**SUNDRY NOTICES AND REPORTS ON WELLS**

(other) Amend 9-331C dated 08-30-79

8. FARM OR LEASE NAME  
Southland

9. WELL NO.  
2-Y

# SURFACE WELL CONTROL EQUIPMENT

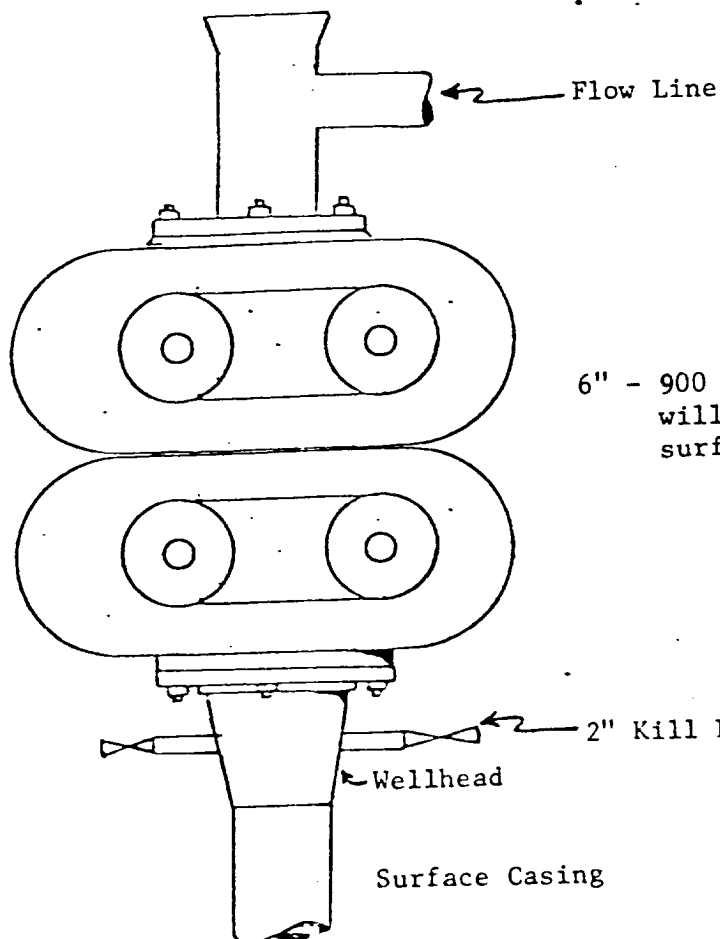
\*Amended surface well control equipment:

See attached schematic of Blowout Preventer.

6" - 900 Series Mechanical Double Ram BOP which  
will be tested to 500 PSIG after setting of  
surface casing
